**IN THE MATTER** Private Plan Change 56 – Lockerbie, Morrinsville

**STATEMENT OF EVIDENCE OF VINISH ANAND PRAKASH**

**Dated 13 July 2022**

**Figure 2: Roothing Connections (road network shown within Lockerbie subdivision and PC 56 area is Indicative only)**

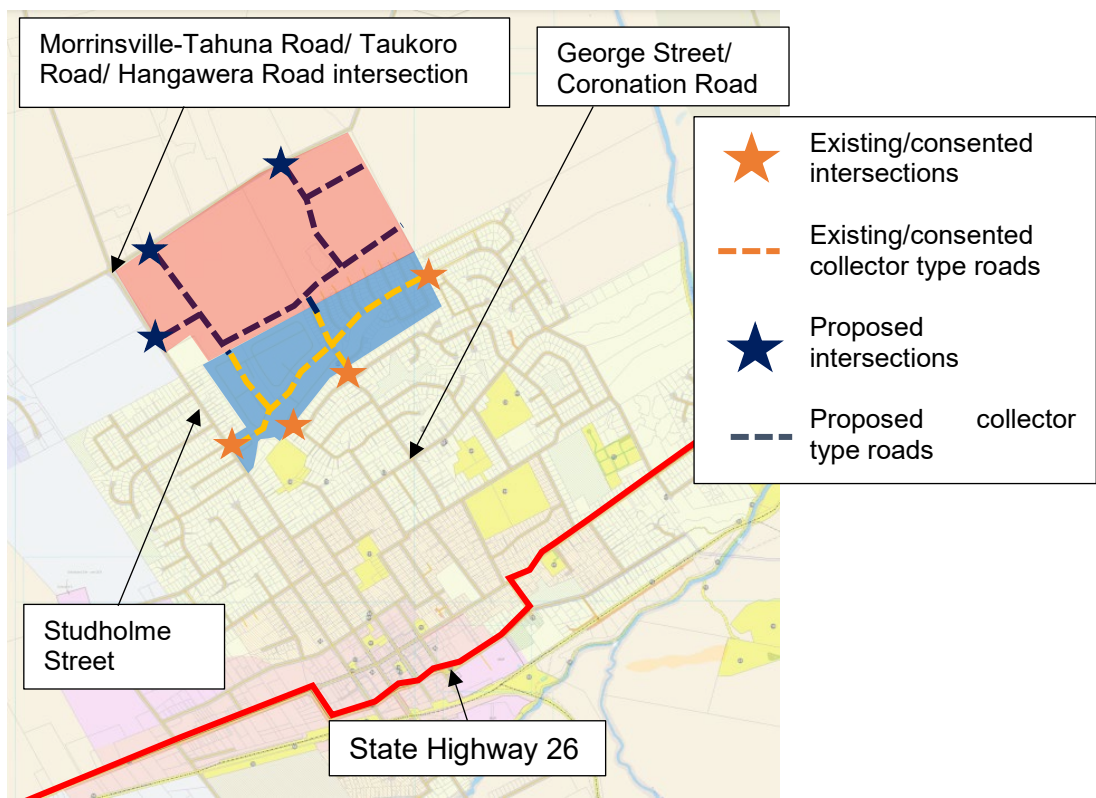
23. There are no turning facilities at the existing George Street/Coronation Road crossroads intersection. I consider that the increase in traffic is likely to result in an increased crash risk at the intersection, both for vehicles turning right or travelling across the intersection on George Street.

24. I reviewed the safety assessment<sup>3</sup> of the George Street/Coronation Road corridor prepared by Mr Hall ("Safety Assessment"). While I agreed with Mr Hall that the predicted injury and DSi crash rates remain very low, they increase by 20% when comparing the plan change to the consented development and more than double when compared to the pre-development traffic volumes.

28. From Mr Hall's evidence (paragraph 32), I understand that implementation of right turn bay markings, as shown in Figure 5 of Mr Hall's evidence, will be included in the Private Developer Agreement (PDA). When comparing the proposed plan change and consented development, I consider the proposed treatment is acceptable to address the increase in traffic and associated increase in crash risk at the intersection.

**Figure 3: Austroads Turning Warrants – right turning traffic from Coronation Road (east)**

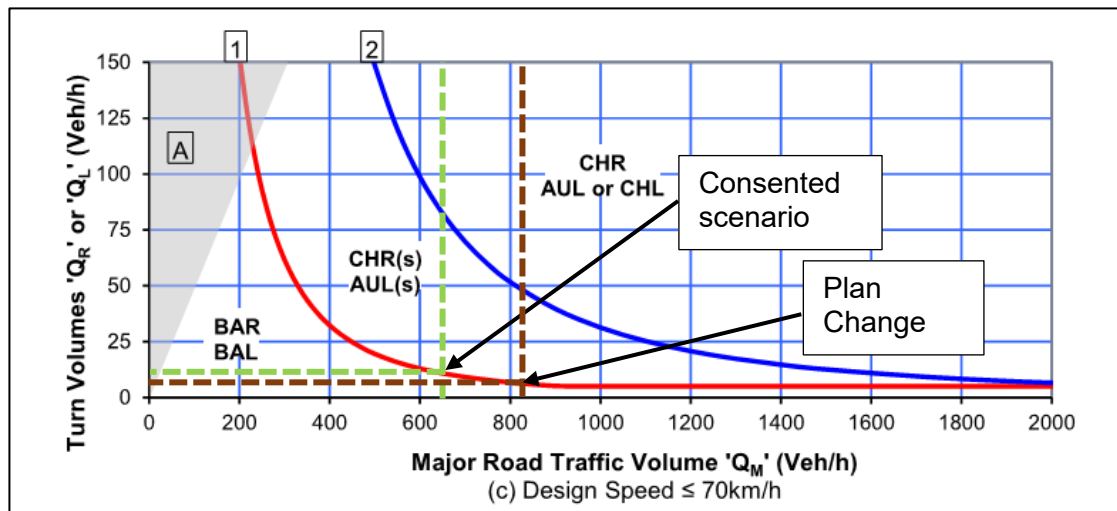
26. In both the consented and PC56 scenarios, a right turn treatment is warranted if there are more than 5-10 veh/hr turning right from Coronation Road (east) into George Street. In my view, the right turn movements of the PC56 scenario are likely to be greater than 10 veh/hr and a channelised right turn treatment is warranted at this intersection.

**Figure 4: Morrinsville-Tahuna Road Cross-Section**

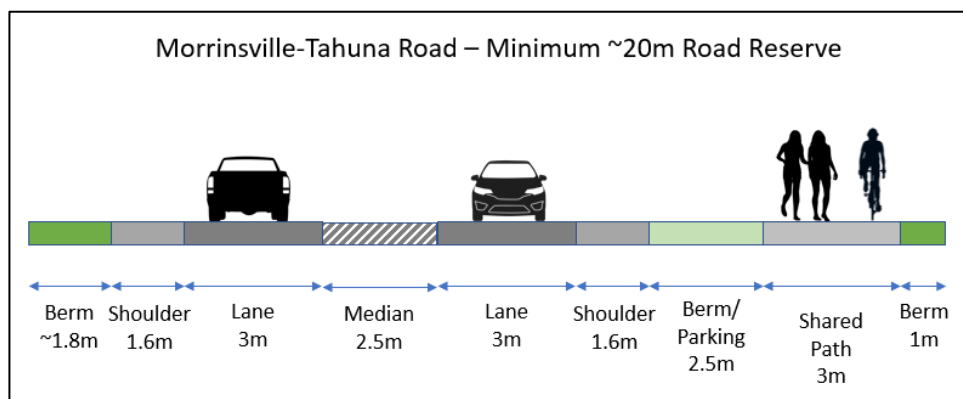
31. This cross-section is based on a 20m wide road reserve. Using the MPDC Webmap Tool<sup>5</sup>, I measured the width of the Morrinsville-Tahuna Road road reserve north of the Rhoda Read hospital. The road reserve varies from approximately 20m to approximately 50m at the intersection with Taukoro Road/ Hangawera Road. South of the Rhoda Read hospital, I measured the road reserve as 20m wide.

32. Based on a 20m wide road reserve the proposed cross-section results in a 1.8m wide berm on the western side of the road. I consider this appropriate for the current Rural-Residential Zone on that side of the road.

33. I consider that the Morrinsville-Tahuna Road cross-section proposed in the PC56 District Plan Provisions is appropriate for the future form and function of Morrinsville-Tahuna Road. I consider that it will support urbanisation of the corridor, provide safe property access and support a reduction in the posted speed limit from 100km/h to 50km/h.

**Figure 5: Proposed Taukoro Road Cross-Section**

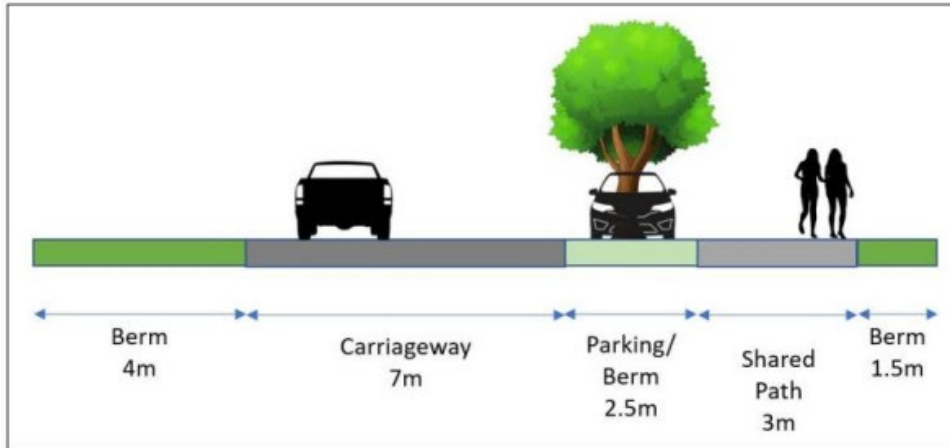
56. I consider that the proposed cross-section is appropriate for the volume and mix of traffic expected on Taukoro Road. The 7m carriageway provides sufficient space for two-way vehicle movement and a shared path is provided to separate pedestrians and cyclists from traffic. Some cyclists may choose to cycle along the road, but the 7m wide carriageway provides sufficient space for traffic to pass cyclists.

57. I acknowledge that there are existing sight distance restrictions on Taukoro Road due to the vertical geometry on Taukoro Road.
58. Taukoro Road is currently posted as 100km/h which means that the sight distance required<sup>16</sup> at an intersection is 290m (based on an operating speed of 110 km/h). Where Taukoro Road is urbanised I anticipate that there will be a reduction in the posted speed limit. If a 50km/h speed limit is implemented then the operating speed of 60km/h would require 115m sight distance. At an operating speed of 70km/h the required sight distance is 140m. I consider that the sight distance deficiencies on Taukoro Road can be improved during detailed design of the intersections and urbanisation of Taukoro Road.

60. I consider that the proposed urbanisation and the provision of two intersections on Taukoro Road is appropriate for the anticipated level of increased traffic on Taukoro Road. In my view, the existing deficiencies in sight distance can be addressed through the proposed urbanisation and approval of the detailed design by MPDC.
